Submissions Report

Mixed-Use Development with In-Fill Affordable Housing

2-6 Pilgrim Avenue and 11-13 Albert Road, Strathfield

SSD-80432461

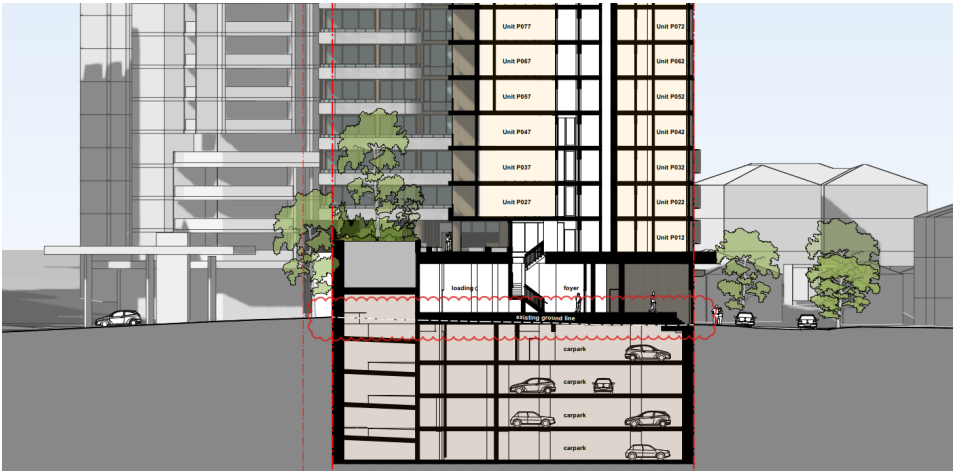
Matter Raised	Applicant Response
1. Boundary Conditions	
<i>(a) Further consider the proposal's setbacks and with the adjoining petrol station at 9 Albert Road, including: i. required buffers to vent point, tank filling connection points, pipes and underground fuel storage areas and consider the risk of vapor travelling and trapping in the underground car park.</i>	The Proposal includes a zero setback at Ground Level along the southern boundary with the adjoining property at 9 Albert Road (service station site). This is consistent with the previously approved Planning Proposal (PP-2020-178) and Site Specific DCP, resulting from that approval and subsequently approved Development Application for the site (DA2020/256). Both the Planning Proposal and the Site Specific DCP, anticipate the potential for a coordinated redevelopment across the two (2) sites bounded by Raw Square, Albert Road and Pilgrim Avenue (including 9 Albert Road). The Planning Proposal, which was supported by both the Regional Planning Panel and Strathfield Council specified that future redevelopment of both the subject site and 9 Albert Road should: • have a zero-lot boundary setback along their common boundary for the extent of the ground floor & podium level; and • provide a common vehicular access to both sites from the northern end of Pilgrim Avenue The proposed development is consistent with the above. Further, the proposed development: • provides for future vehicular access to 9 Albert Road via the proposed driveway off Pilgrim Avenue, which terminates at the boundary of the two (2) properties; and

The walls, off form and precast concrete, are articulated with both vertical and horizontal recesses, glazing and louvres. They offset and balance the more highly articulated facades of the building. The lower levels will be integrated with new planting along the boundary and at podium level.

An existing perimeter planting zone exists, via a raised planter bed, along the boundary of the two sites. This strip is currently partially planted with a number of *Casuarina Equisetifolia*, 'she-oak', a species noted for both their hardiness and ability to grow in constrained locations, as well as their scale and size.

This planting will be augmented by further infill planting of the same species as part of the development.

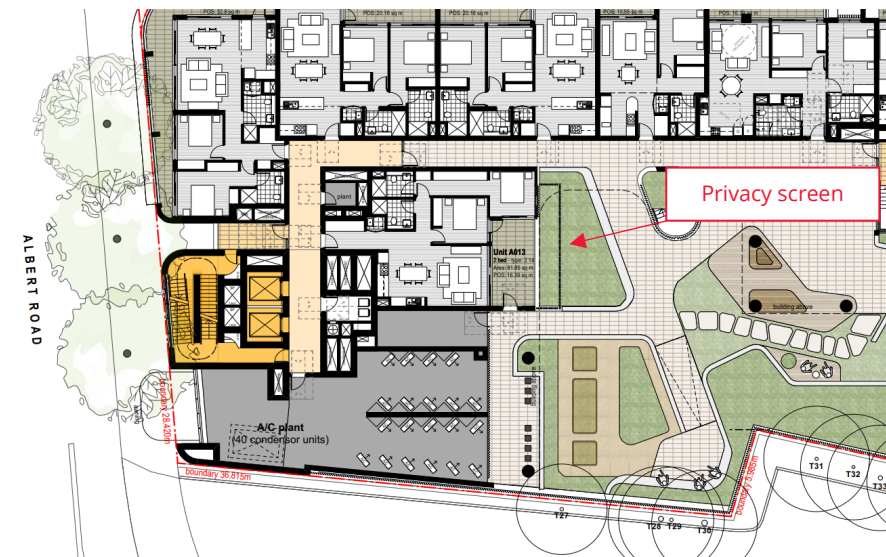
(d) Consider measures to maintain a reasonable level of privacy between the communal areas on levels 04 and 05 and adjacent units.

There is adequate privacy provided between the communal areas on Levels 04 and 05 and adjacent units, with units located to not create any privacy concerns. It is noted that only one (1) unit, being Unit A013 on Level 01, directly faces into the Communal Open Space at the same level as the communal areas. Unit A013 is separated from the communal areas by a 2m high privacy screen to its private open space set within a planter bed of up to 5m in depth. Refer to the following extract for reference.
